Marlboro Gateway

CSP-19001

STAFF REPORT

SUBJECT: Conceptual Site Plan CSP-19001
Type 1 Tree Conservation Plan TCP1-011-2020
Marlboro Gateway

CIRCULATION & PHASING PLAN

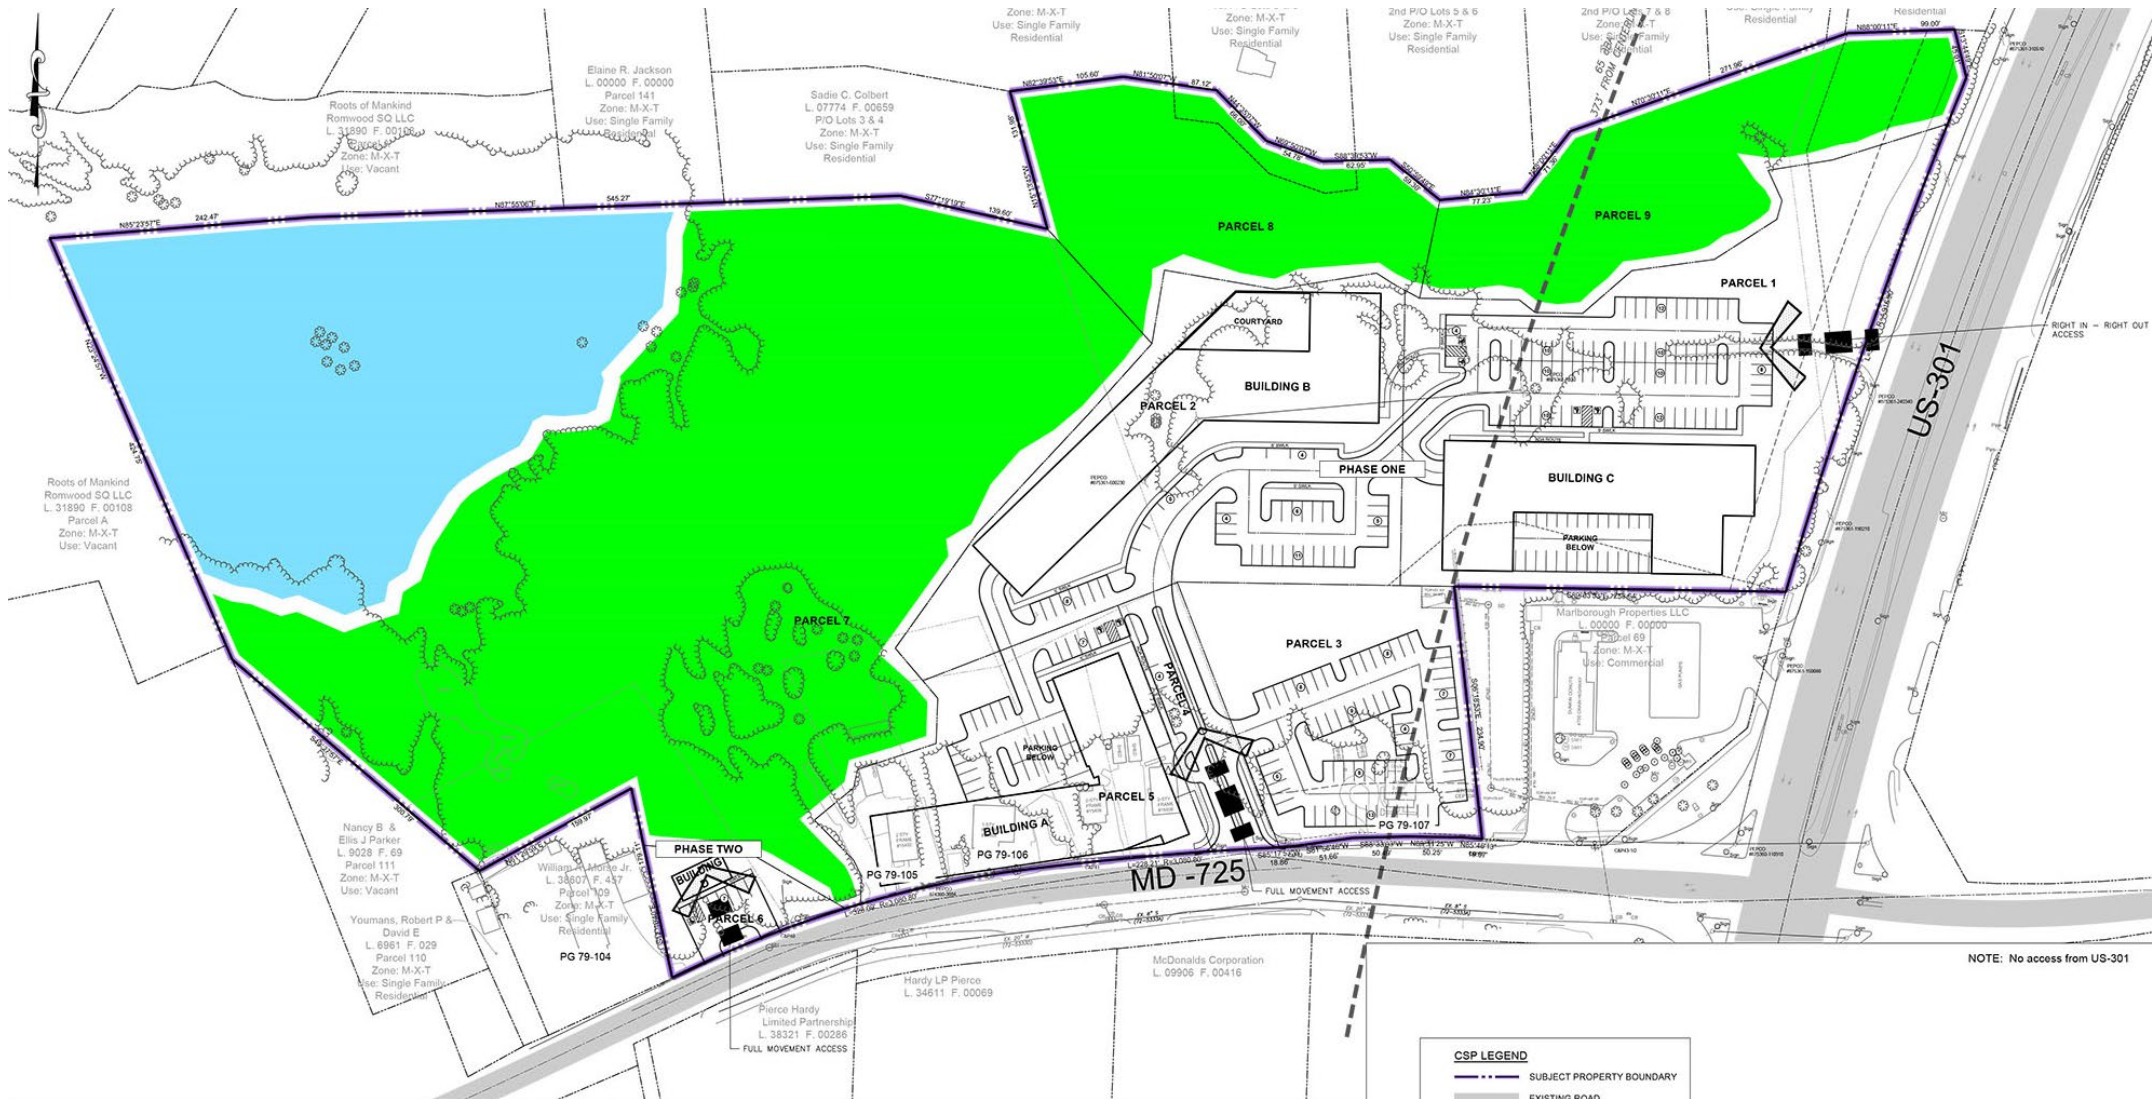
The plan proposes two points of access on MD 725; one access will serve the proposed retail component towards the westernmost end of the site, while the second (and primary) access, will be located to the east and closer to the intersection at US 301. The location where the main access is being proposed, represents a section of MD 725 where the road transitions from two to one westbound lane along MD 725. Furthermore, that proposed location is not in alignment with any existing driveways on the south side of MD 725. Staff therefore recommend that the proposed main entrance driveway be shifted further to the west, where it can be in alignment with an existing driveway on the southside of MD 725. This relocation to the west is also being recommended by SHA. Staff also shares SHA's recommendation that the stand-alone driveway for the proposed retail component should be consolidated with the rest of the development, given the limited trip generation of this component.

With the recommended relocation of the access point, the overall site may have to be redesigned to facilitate better on-site circulation.

- f. Consider relocating the eastern access driveway to MD 725 (Marlboro Pike) to the west, beyond the termination of the merge lane.
3. At the time of detailed site plan, the applicant shall:
